Planning Commission Study Session

TO: PLANNING COMMISSION / DESIGN REVIEW BOARD

SUBJECT: DR22-23 CITYGATE MEDICAL COMMONS

DR22-23 City Gate Medical Commons: Site plan, landscaping, grading and drainage, elevations, floor plans, lighting, and colors and materials for approximately 3.99 acres, generally located southeast of Higley and Baseline Road, on Gary Way, and zoned Regional Commercial (RC).

SITE PLAN
SCALE: 1" = 40'-0"

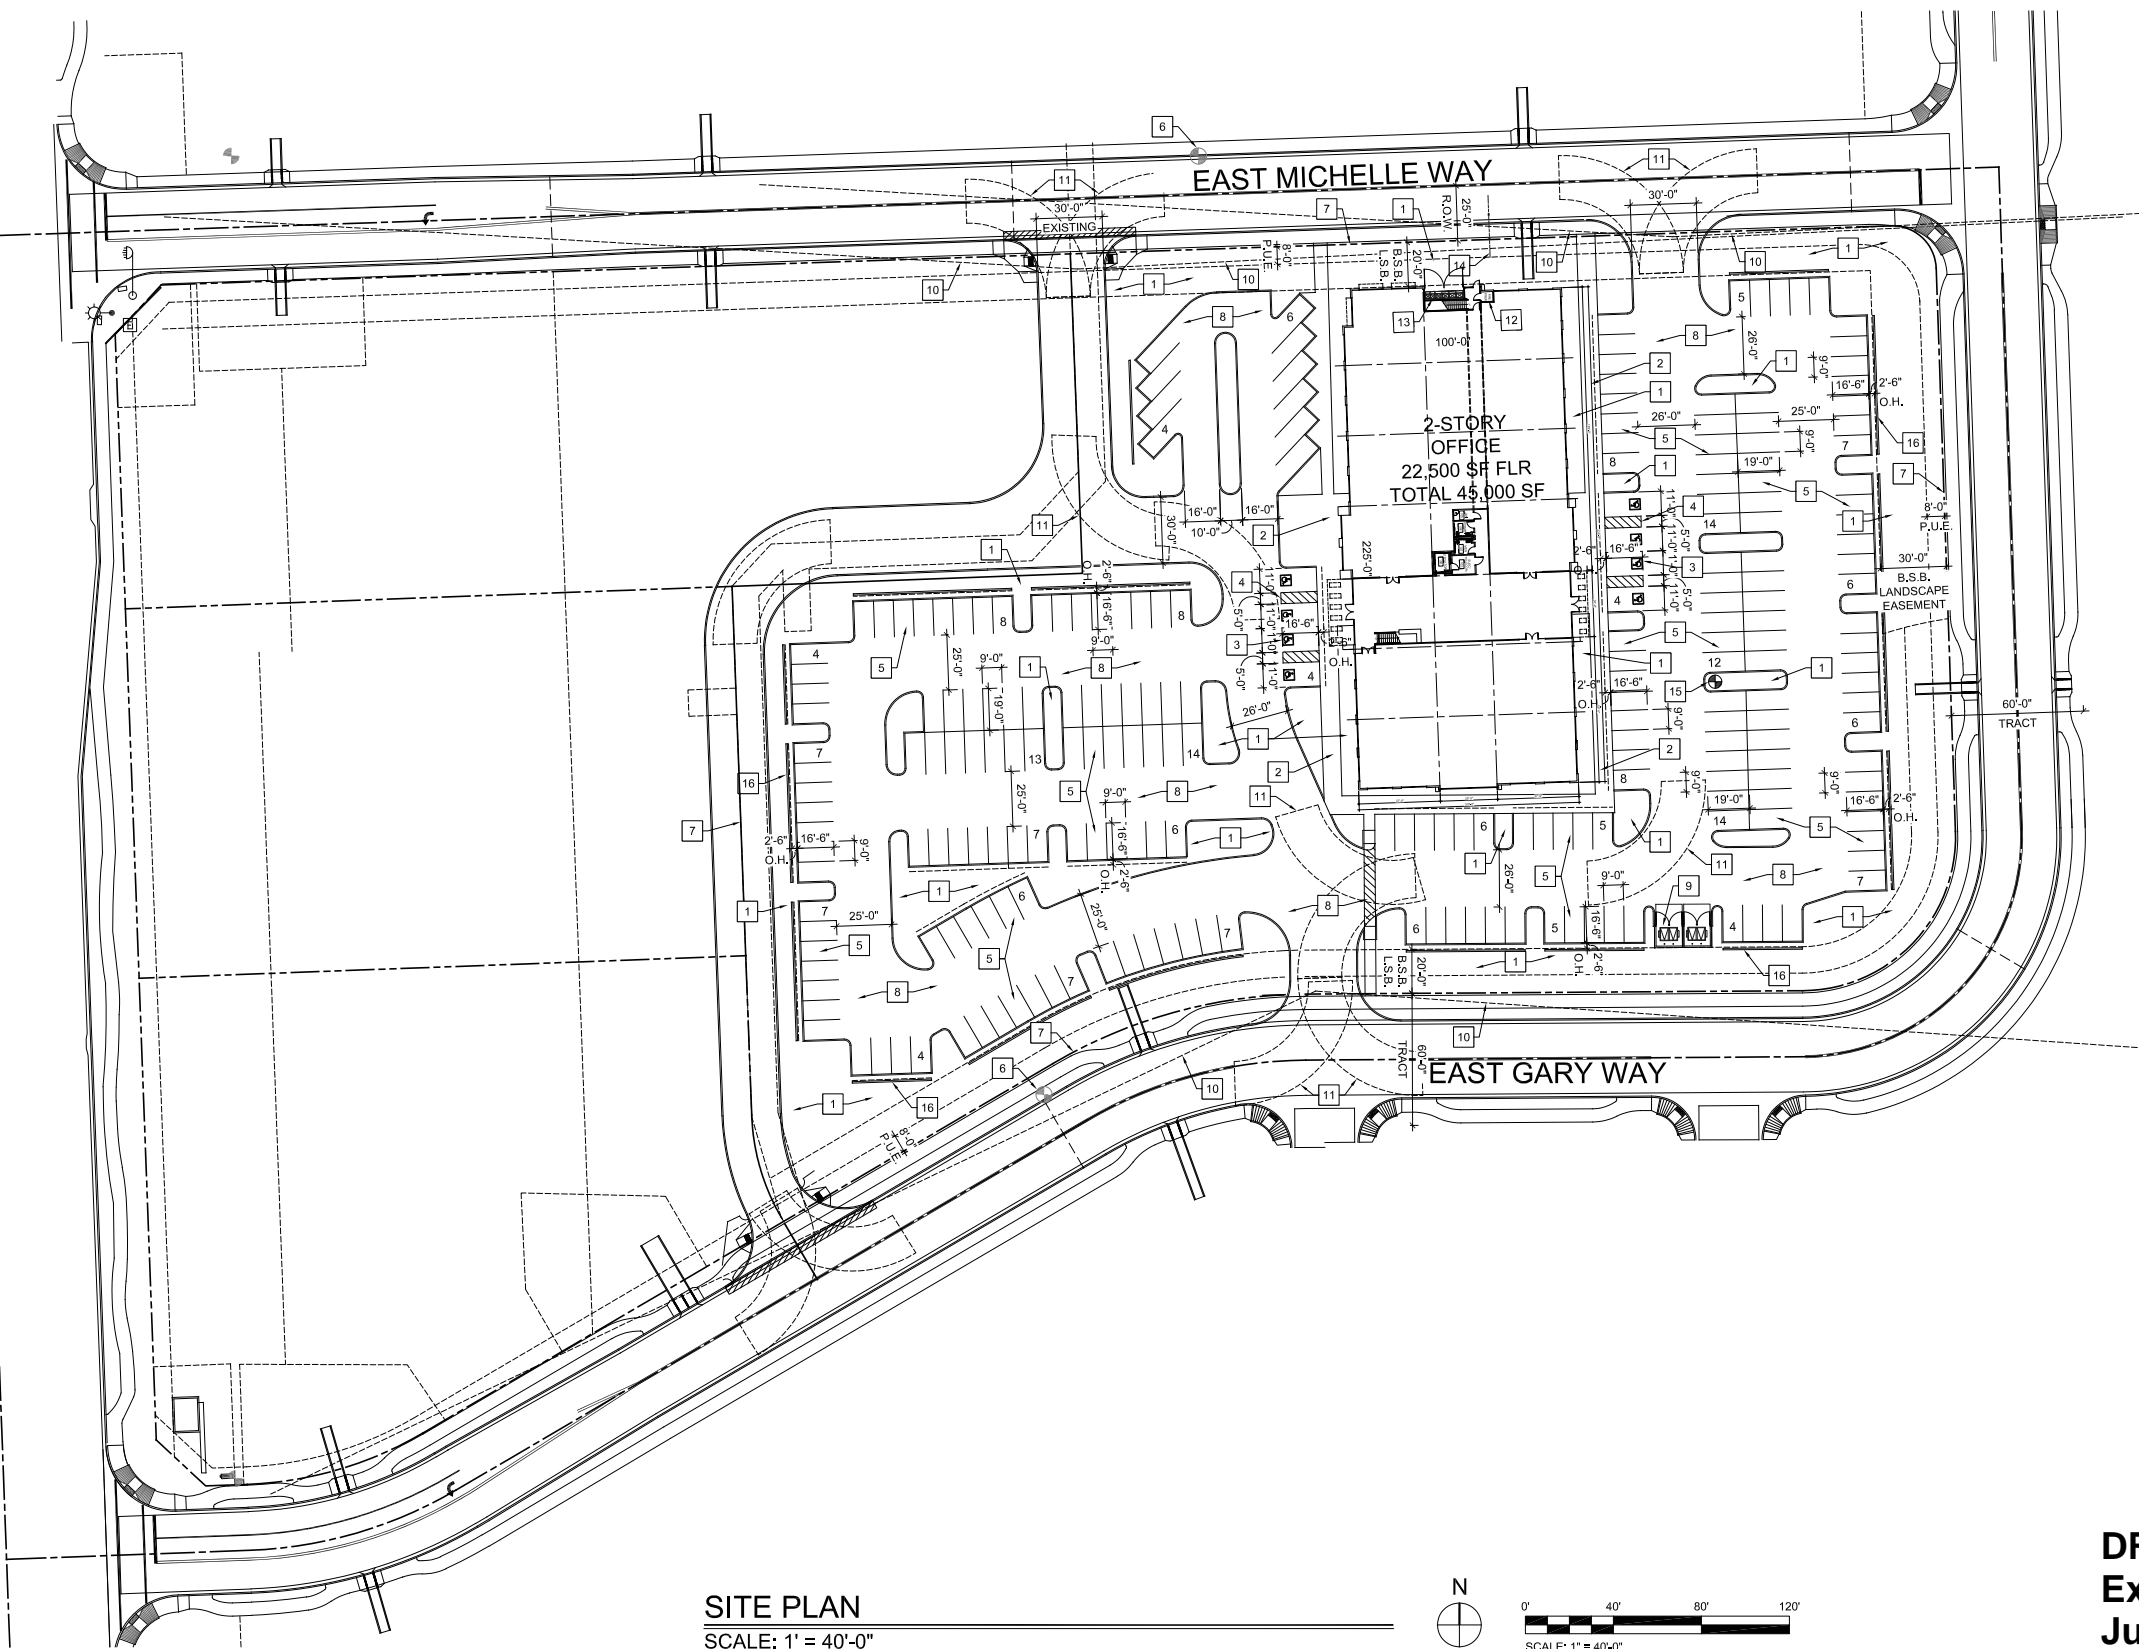
The site is not part of a master site plan and will function on its own and will be required to meet all building and landscape setbacks. Staff continues to work with the applicant to provide internal pedestrian circulation along their western property line in the form of sidewalks, walking paths, etc. that will help to connect this stand-alone parcel with the three parcels across the access drive.

The proposed building is generally centered on the site with parking surrounding the building on all sides except for the northern portion of the building which will abut Michelle Way. Pedestrian access to the site takes place from a sidewalk along Gary Way and transitions into a crosswalk across the southern portion of the parking lot until connecting again to a sidewalk that surrounds the building, giving pedestrians accesses to both the front and rear access doors of the proposed building. Access is also provided via a sidewalk along Michelle Way with two sidewalk connections to both the front and rear portions of the building. Additional sidewalks/walking paths along the western border of the site to help promote connectivity to the three parcels to the west are still needed.
